SUNDRY NOTICES AND REPORTS ON WELLS (DO NOT USE THIS FORM FOR PROPOSALS TO DRILL OR TO DEEPEN OR PLUG BACK TO A DIFFERENT RESERVOIR. USE "APPLICATION FOR PERMIT" (FORM C-101) FOR SUCH PROPOSALS.) 1. Type of Well: Oil Well <input checked="" type="checkbox"/> Gas Well <input type="checkbox"/> Other <input type="checkbox"/>		WELL API NO. 30-025-27866

Plug And Abandonment Procedure

Lansford #005

Action 289381

Proposed Wellbore Diagram

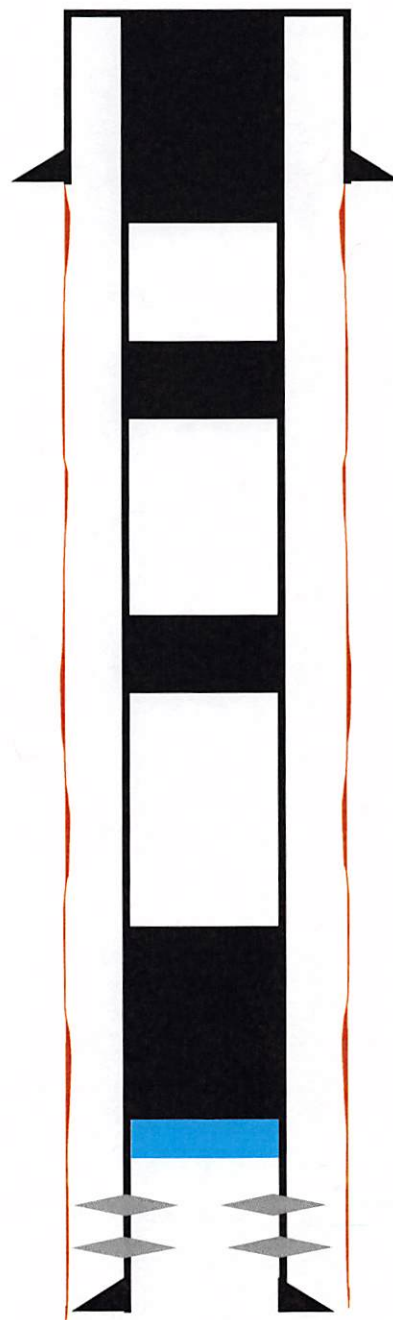
Created By	Condition	Condition Date
jagarcia	Plugs must be inside/outside if no cement exists outside casing.	12/1/2023
